POST OCCUPANCY EVALUATION REPORT

AEROSPACE TECHNOLOGY CENTRE

MARCH 2015

Room B13

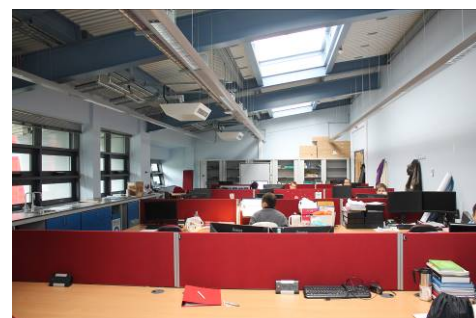
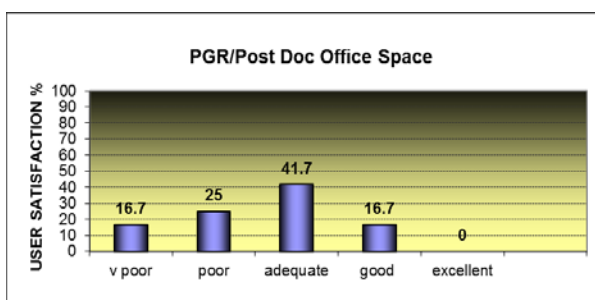
The PGR/Post Doc Office space attracts the most dissatisfaction. It should be noted that this room (B13) was originally intended to be used as a laboratory. As a shared office it has attracted some comments due to temperature conditions and natural lighting. Despite this, 58% of respondents found the working space to be satisfactory.

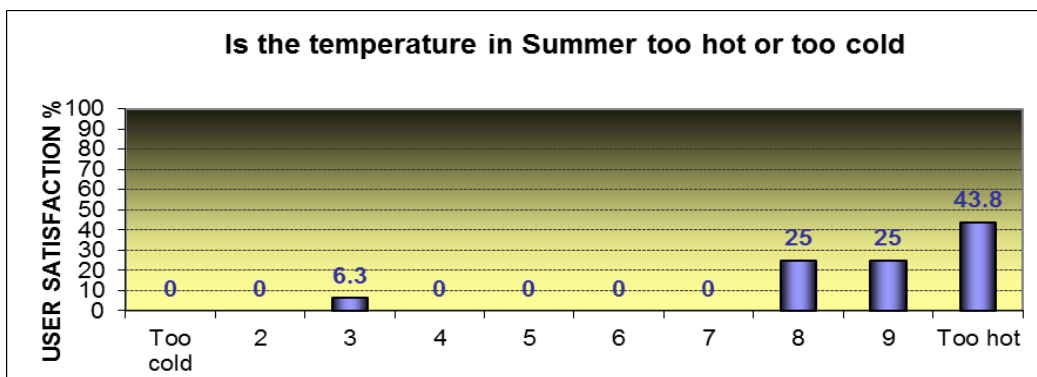
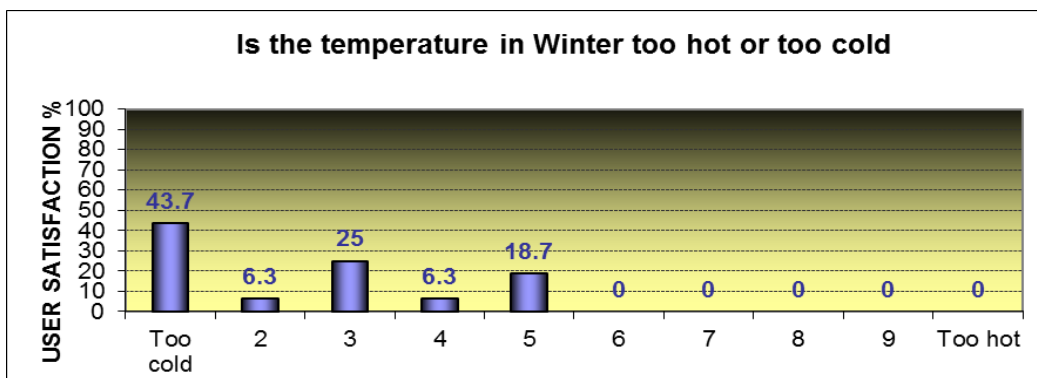
Regarding temperatures in the building, the charts show some interesting results both for winter and summer. In winter respondents are indicating that 82% are too cold whilst in summer 95% are too hot.

The temperature control is an ongoing issue and in part reflects problems caused by the main contractor going into administration. Further works have been carried out post contract to the heating and cooling systems and control of solar gain. For example, the Board Room has been fitted with comfort cooling.

- i) Carry out further assessment of the heating and cooling in the building and make adjustments/modifications where necessary*
- ii) Consider installing additional window blinds*
- iii) Consider providing further advice/guidance to building users on the automatic window operation*

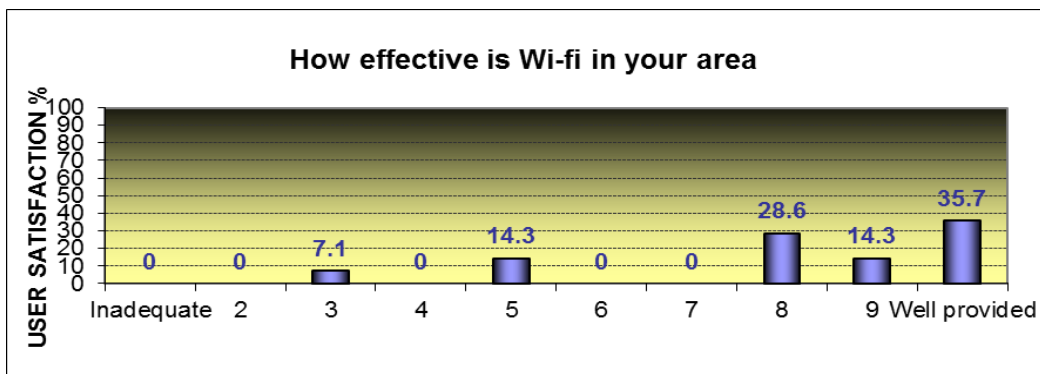
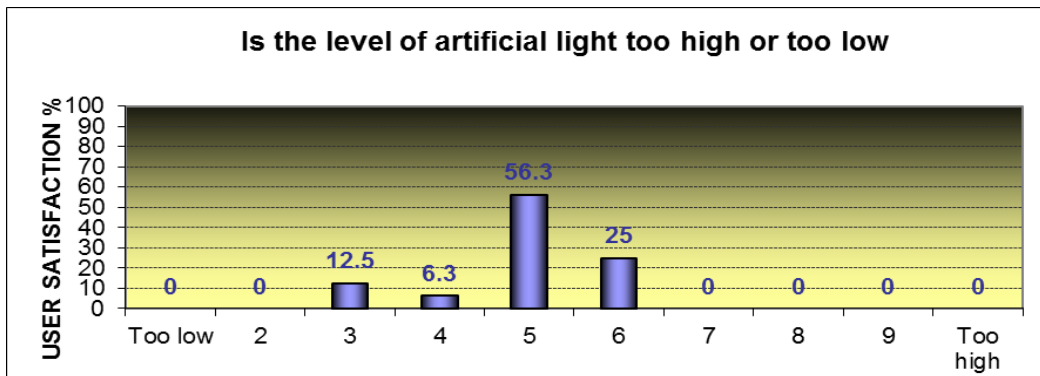
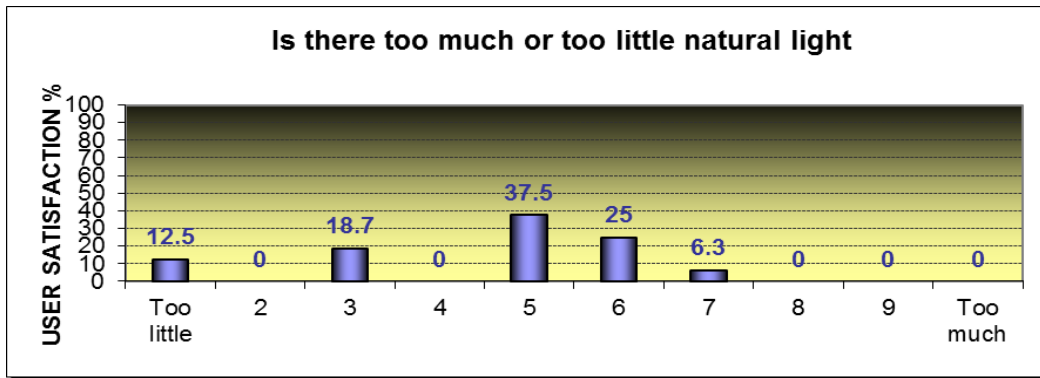
Comments on lighting relate mainly to the operation of the lighting controls and movement sensors in B11 and B13. This is a common issue with lighting in office areas but it should be noted that the levels of controls incorporated into the building are a requirement to satisfy Building Regulations and achieve the BREEAM accreditation.

- i) Continue to improve the communication with the Operations and Facilities Team*
- ii) Check the location of the lighting sensors in the PGR/Post Doc office*
- iii) Review the cleaning regime to the toilet areas*
